MEMORANDUM

To: Montgomery Township Planning Board

Re: **Sharbell Building Company, LLC**
Amended Preliminary and Final Major Site Plan
Village Drive
Block 28009, Lots 1, 2 & 3
PMUD-2 Planned Mixed Use Development Zone, Area A-2

Date: September 1, 2023

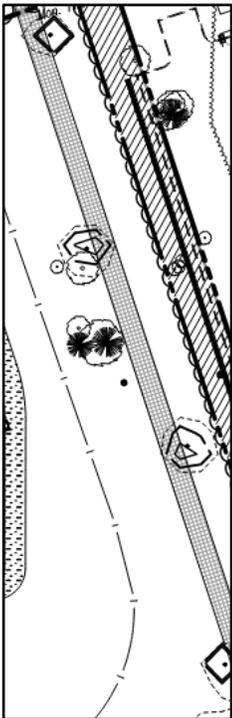
As of now the applicant has not proposed make-ready or EVSE spaces. The applicant is proposing 56 spaces. 15% of 56 is 9 ($56 * .15 = 8.4$ and rounded up is 9). The applicant should revise their plan so that at least three (3) of the spaces are EVSE spaces and six (6) are make-ready spaces. The applicant should also indicate the schedule for conversion from make-ready spaces to EVSE spaces in the event they opt not to install nine (9) EVSE spaces from the outset.

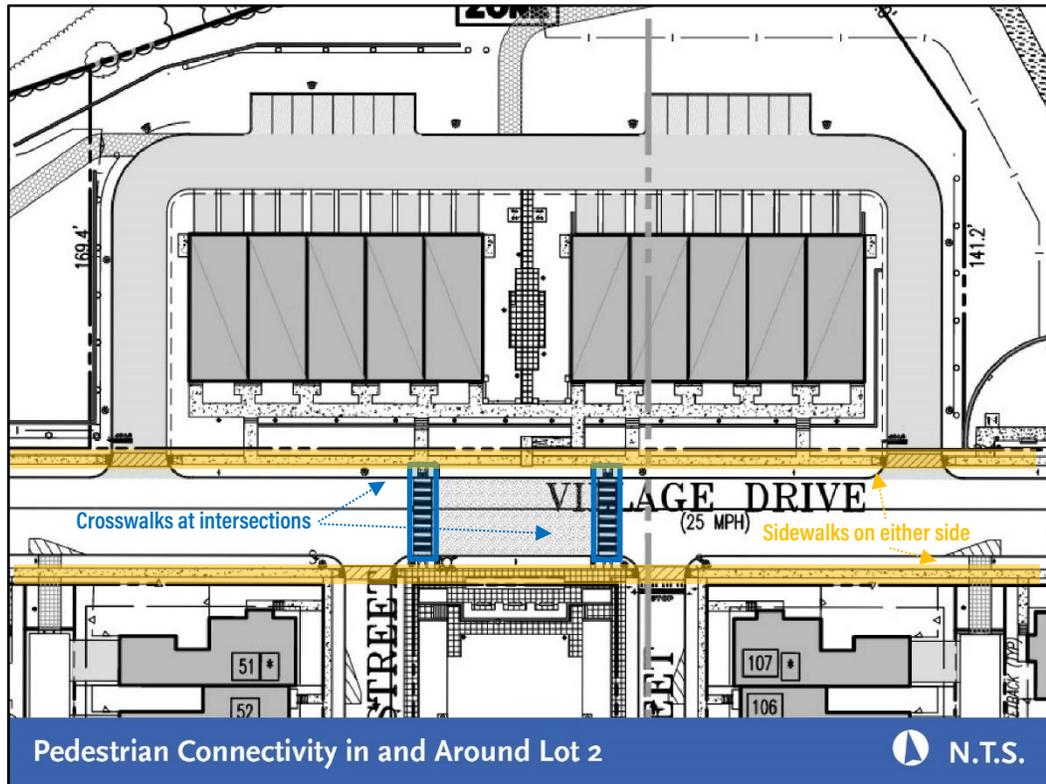
- 4.4. **Pedestrian Connection to Hillside Development to the North: Additional information is required.** Pursuant to Per §16-6.5k.11(e)(5), a walking pathway, with low-wattage lighting, shall be provided connecting Area A-2 with the existing Hillside development north of Area A-2. As indicated in the image to the left, there is a walking path with low lighting indicated on the plan that connects Village Road to the lot(s) north of the multifamily building. The applicant should confirm that it is intended for this purpose.

Portion of Multi-Family Buildings to Face Open Space

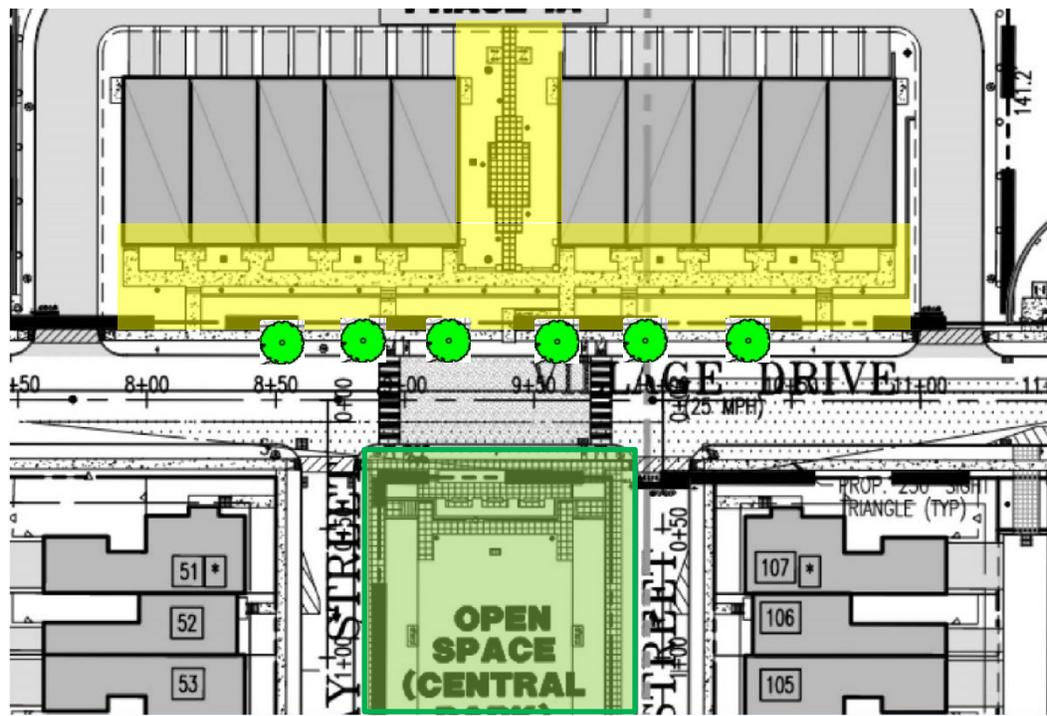
- 5.4. **Interface With Open Space Parcel:** *Additional may be required.* As indicated in the following image, the façade of the multifamily building's interfaces with open space across Village Drive. The building contains multiple walkways leading to the Village Drive sidewalk, which contains crosswalks for safe pedestrian crossing. There are plantings proposed along the building frontage which unify the development with the open space. Finally, the central courtyard between the multifamily buildings creates an attractive and complimentary view and use for residents, as it continues the theme of mixing residential living with nature.
